TECHNICAL SERVICE BULLETINNo.24/2014
09 May 2014

Subject/Concern: Tray in overhead console stays open	
Model:	
Galaxy 2006.5 (03/2006-)	Build Date: 01.02.2006-12.12.2014 Build Code: 6Y-EG Assembly Plant: Genk

Summary

Example for damaged foam inside the release button

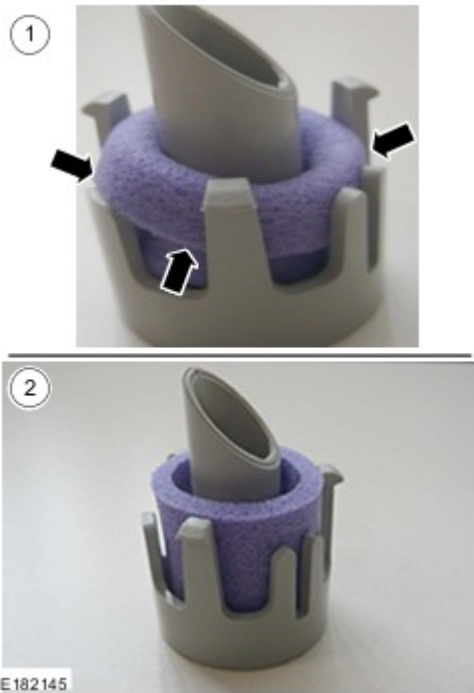
Should a customer express concern that the tray in the overhead console stays open, the probable cause is the spring foam folding itself inside the release button.

Item	Description
1	Spring foam folded itself inside the release button
2	New service part

The release button with foam is available for Galaxy 2006.5 as a spare part for servicing purposes. Do not replace the complete overhead console tray.

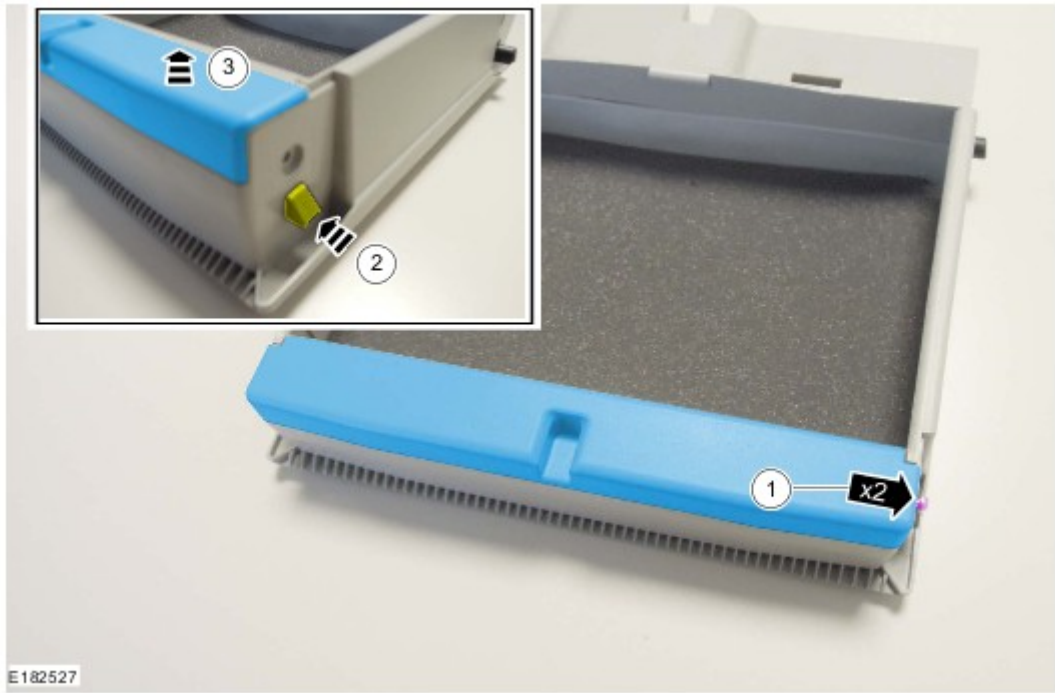
- 1. **NOTE:** It is not required to remove the overhead console tray.
Remove the upper cover.
 - Remove the tray inner trim.
- 1. Unscrew the screws.
- 2. Push in the locks on both sides.
- 3. Remove the cover.

E182146

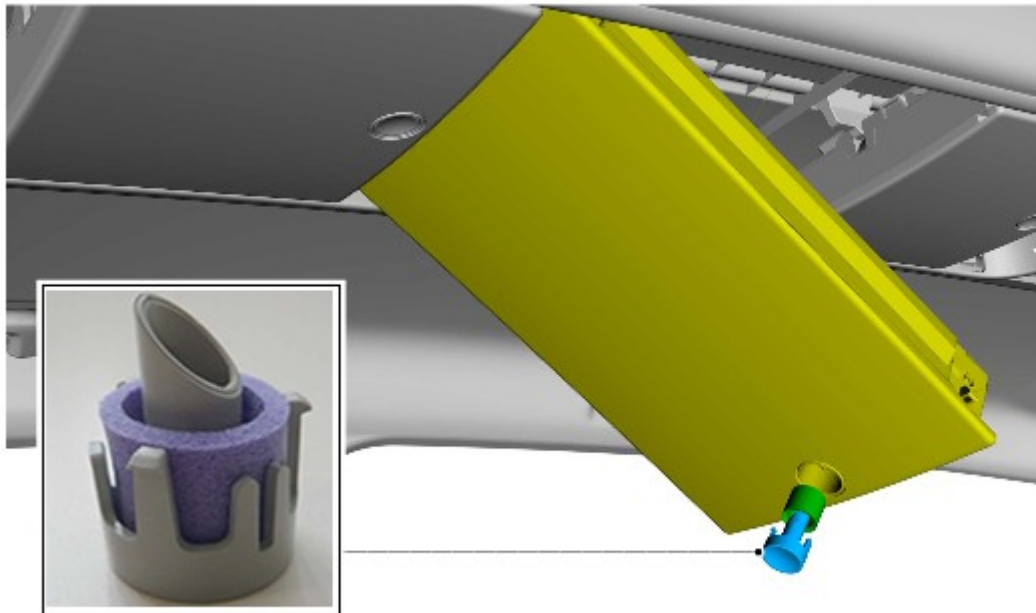
- 2. **NOTE:** Installation position of the release button.
Renew the overhead console release button with foam (see Parts Required).
 - Using a suitable tool, press the release button from inside out.

3. To install, reverse the removal procedure.
